Staff Report

To: BOZAR
From: Jessie Earley, Town Planner III
Meeting Date: DRC, March 17, 2025
RE: 801/803 Red Lady Avenue (Ochs) Primary Review

PROJECT TITLE: Ochs (801/803 Red Lady Avenue)

SUMMARY: Consideration of the application of **Margaret E. Ochs and David J. Ochs** to site an addition on the existing single-family residence and an addition to the existing accessory dwelling to be located at 801 and 803 Red Lady Avenue, Block 65, Lots 17 and 18 in the R1 zone.

Proposed Site Plan

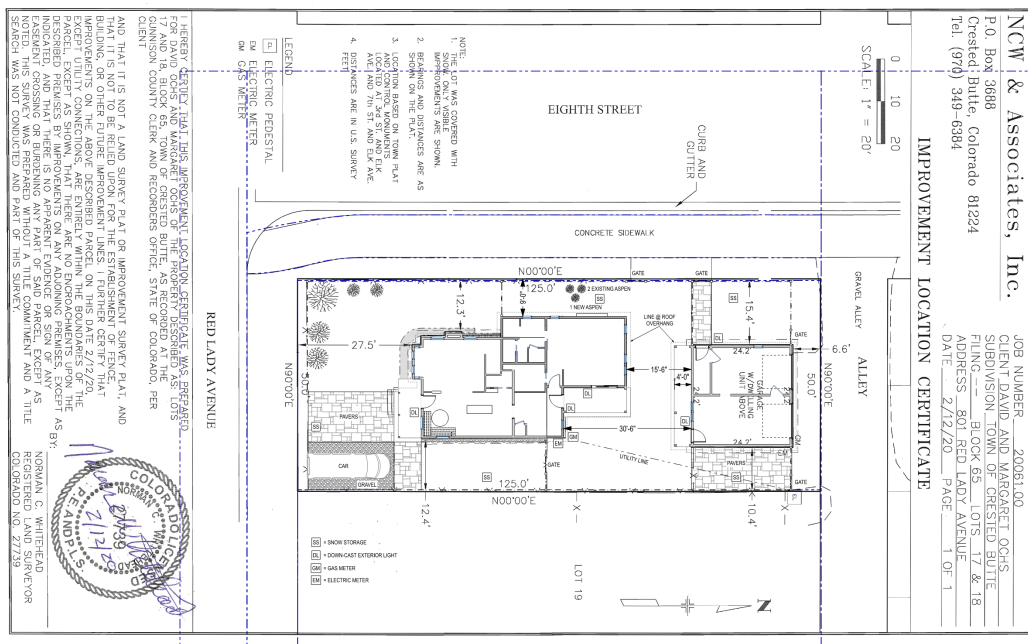
GL	Staff Analysis	DRC Recommendation
Topography	Topography has not been included on the site plan. The home is already built, and the height will not change.

2.8 Drainage	Drainage information has not been provided. Drainage arrows must be shown.	
Easements	NA	
2.16 Substantial landscaping	Most landscaping is existing and will be maintained. Provision of a final landscape plan will be required for review and approval if revisions are proposed after permitting prior to a CO.

2.19 New trees	There is one new aspen tree proposed for the west. Support.	
2.16 a./ 2.20 Native plantings	Ground cover is not noted for disturbed areas and must be, but is encouraged to be native grasses by the GL.

2.16 e Pervious materials 2.28 e & f Parking substrate	Pavers are noted on the south for the parking and north for snow storage area and then a small walkway on the west elevation for the ADU. Confirmation is

needed if these will be sand set, permeable pavers.	
(2.37-2.40)/ 16-17-40 Exterior Lighting	Exterior lighting has been called out as down lighting. The Chair will need to see the final fixture to ensure that they are in compliance. Any existing exterior fixtures must be replaced if they do not meet current standards as well.	
Solar 2.10	NA	
Utilities	Utility lines have been shown for dry utilities. However, water and wastewater lines must also be shown to ensure that they will not be impacted. Adjacent rights of way have been included to scale Ruth's Road.	
2.7 Snow Storage	Snow storage has been provided onsite and meets the 33% requirement of the areas to be plowed.	
2.25 Fences	There is an existing fence noted on the existing site plan. This will be revised based upon the addition and is shown on the proposed site plan.

Proposed - West

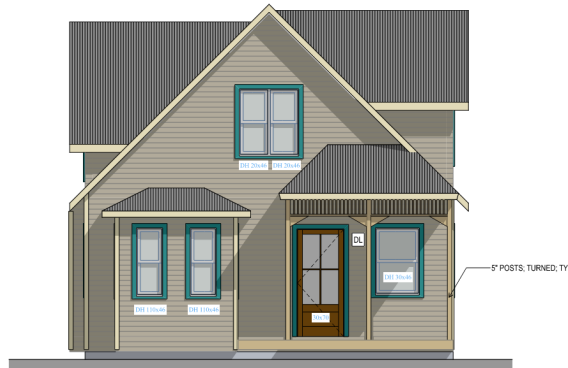
4.54 Vertical emphasis	<p>Windows are proposed as one over one, double hung and double hung style casement, with simulated divided lights which is consistent with historic homes.</p> <p>The windows are proposed as double hung and, casement (egress), which is supported by GL 4.54 a with the notation of simulated divided light. Window operations are noted on the plans and a window schedule should be included.</p> <p>Per GL 4.54 c, the windows on the west elevation must include divided lights.</p>

4.58 Groupings of 2 or more windows	The three pack of square windows on the west, appears to conflict with GL 4.58, as they will be highly visible from Eighth Street. The windows must be separated by siding to be single windows.

4.58 c. Window sizes	<p>No change on the front elevation.</p> <p>It appears that there are not more than six window sizes on the north and east elevations, as required by GL 4.58 c. It appears that there would be seven window sizes on the west elevation, which is in conflict with this GL.</p>	
4.59 Window and door trim	Trim will match existing (1"x4", off-white). Trim surrounds appear consistent with the GL.	
4.60 Divided lights	Windows will match existing double hung style windows. The square windows must have divided lights.	
4.61 Transom windows	NA

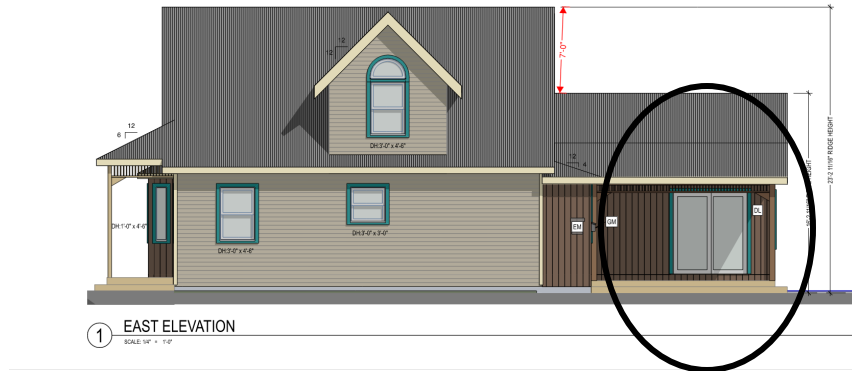
GL	Staff Analysis	DRC Recommendation
4.64 Primary door	Existing, no change.	
4.65 Primary door	Existing, no change.	
4.66 Secondary doors	<p>The rear door is proposed as a wood $\frac{3}{4}$ light door, which appears consistent with the GL.</p> <p>There is another door on the east elevation, which must be confirmed for type and material. It appears that the door might be a sliding glass door, which are not allowed by GL 4.66 a. The door can be a French door.</p>

South elevation - ADU

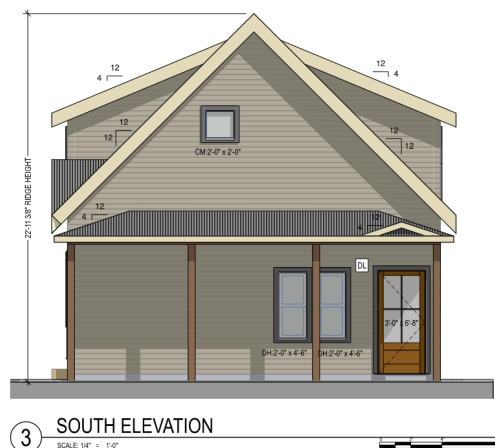
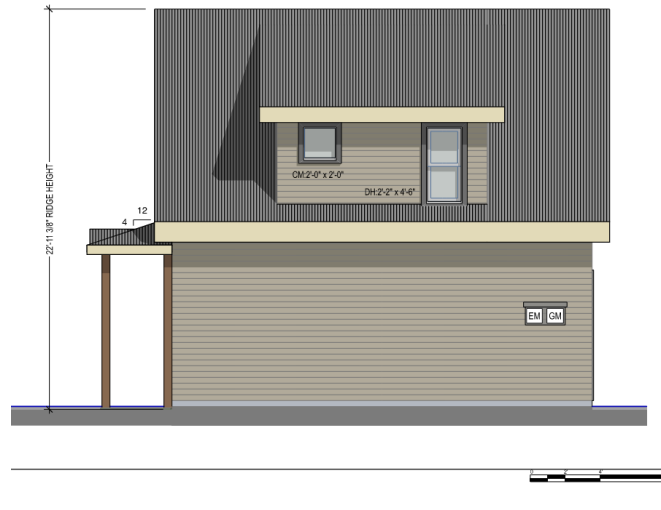
GL	Staff Analysis	DRC Recommendation
4.49 Covered porches	The new porch, as proposed, is simpler than the primary building. Support.	
4.50 Mix of styles	NA	
4.51 Side or rear porches	NA

There will be new posts, sizing must be confirmed (medium/dark brown).
